**CAMPUS
IMPROVEMENT
PROGRAM 2014–2020**
STATE-SIGNIFICANT
DEVELOPMENT
APPLICATION (SSD 13_6123)
SEPTEMBER 2014

SUPPLEMENTARY
RESPONSE TO
SUBMISSIONS

KEY ISSUES - CIP RESPONSE TO 2ND ROUND OF AGENCY SUBMISSIONS SEPTEMBER 2014

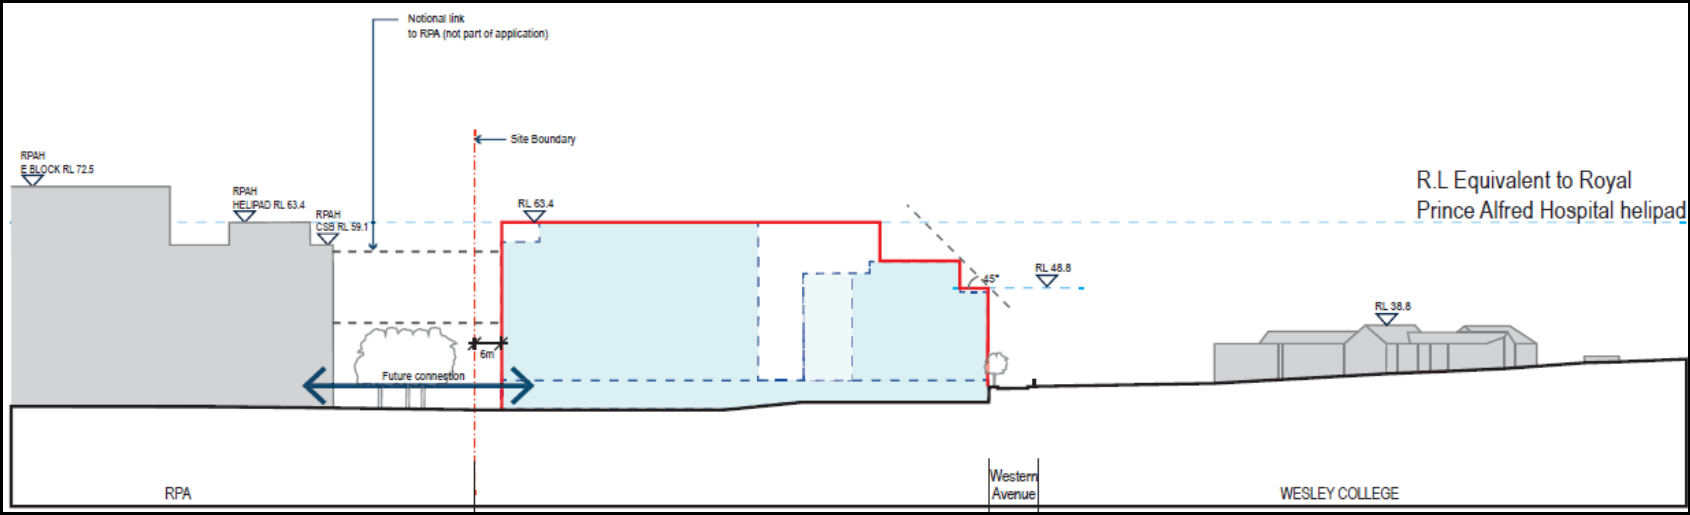
The University's RtS refers to producing a 6 metre setback from City Road, yet the precinct envelope plans refer to "Nil Setback" in the area.	Amended Plan SSD-B-11 (see comments above). To clarify the University's intention, and to avoid further confusion, the words 'Nil Setback' are removed from the CIP City Road Envelope Plan drawing SSD-B-11.

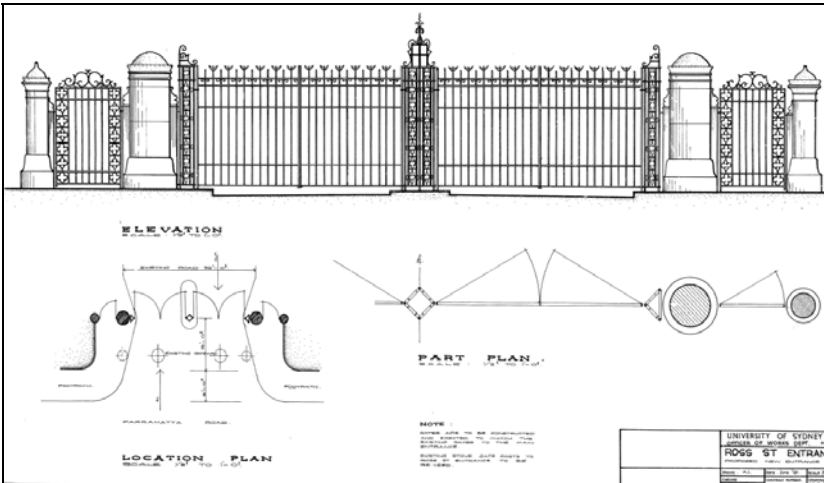
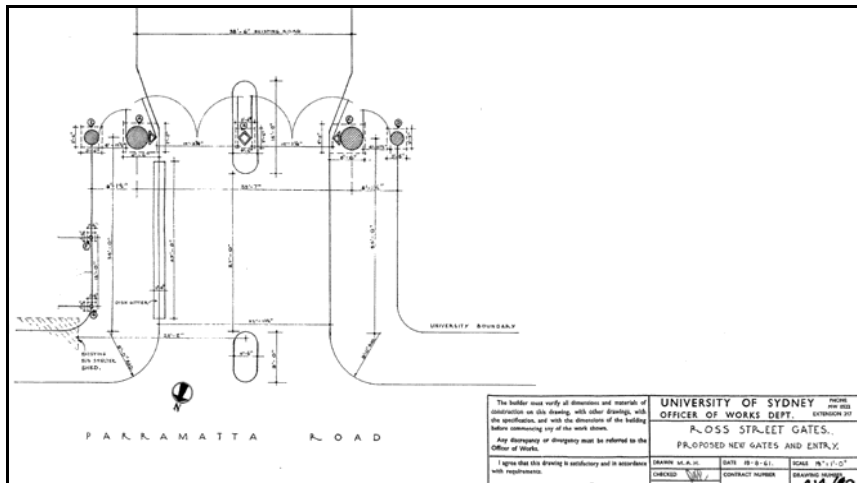
ISSUE	THE UNIVERSITY OF SYDNEY- CIP RESPONSE
	The Heritage Impact Assessment report for the Engineering Precinct (Graham Brookes & Associates concludes on pp.61: <i>"The loss of the highly significant 1960s Chemical Engineering Building (J01) component of the Precinct is unfortunate in heritage terms, but can be supported if it becomes an effective mechanism to achieve the broader upgrading and continuity of the remaining significant buildings and important circulation spines within the Precinct."</i>  Chemical Engineering Building facing the Boardwalk
The proposed building envelope (chemical Engineering site) will intrude on views of Cadigal Green from the boardwalk's northwest splay. (CoS)	Disagree: The building envelope's northwest splay, when viewed from the Boardwalk, is at a rising topography towards the Green. Existing high growth vegetation defines the northwest perimeter of the Engineering precinct and obscures pedestrian views to Cadigal Green (see photo overleaf). Further on, the junction of Boardwalk and Maze Crescent provides a sense of arrival at Cadigal Green.

ISSUE	THE UNIVERSITY OF SYDNEY- CIP RESPONSE
	Pedestrian View Along Boardwalk Looking Northwest Amended Plan SSD-D-11: The Chemical Engineering envelope is amended by setting back the northern footprint to interpret the former Darlington Road alignment through campus. The CoS has verbally encouraged this initiative. This vista will be incorporated into the future design brief for the redevelopment of the Chemical Engineering site.

Figure 5 – Building J01 Typical Floor Plan

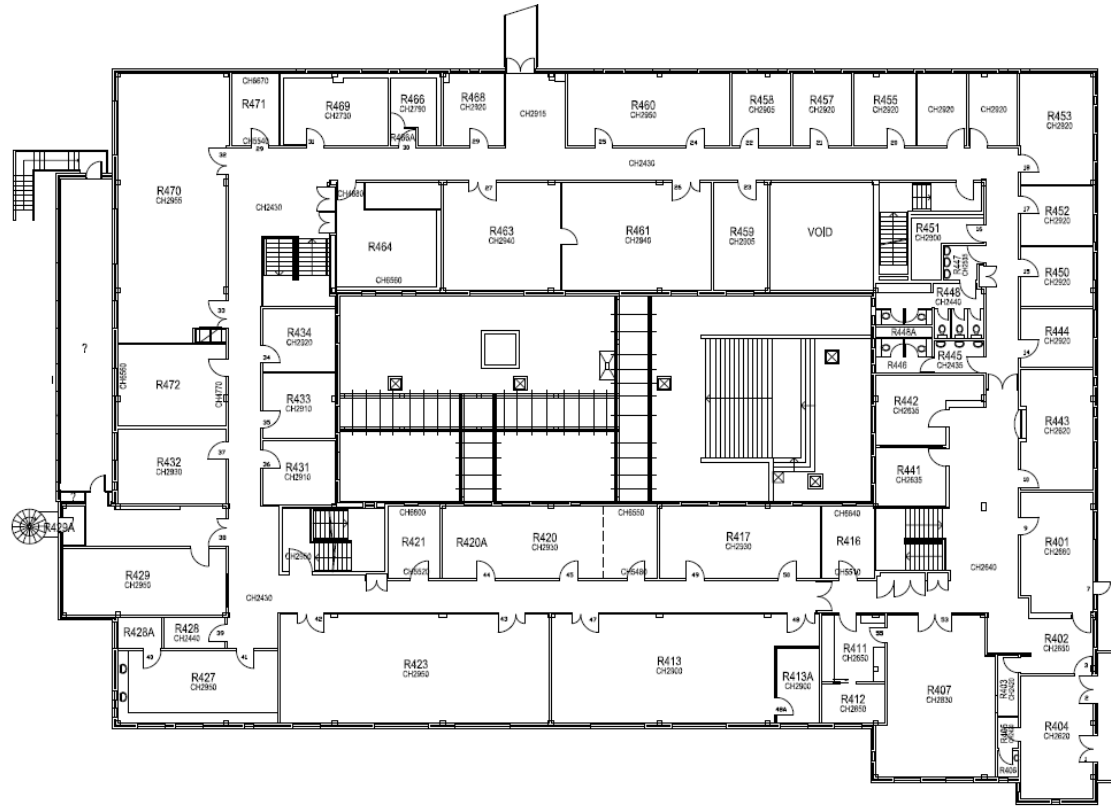
- ii. The current building floor plate is heavily compartmentalised making it extremely inefficient. Refurbishing this building would be very expensive due to the number of load bearing internal walls and the amount of services alterations and internal reconfiguration required. Refer to Figure 5 below for an example of a floor plan demonstrating compartmentalisation of the building layout.
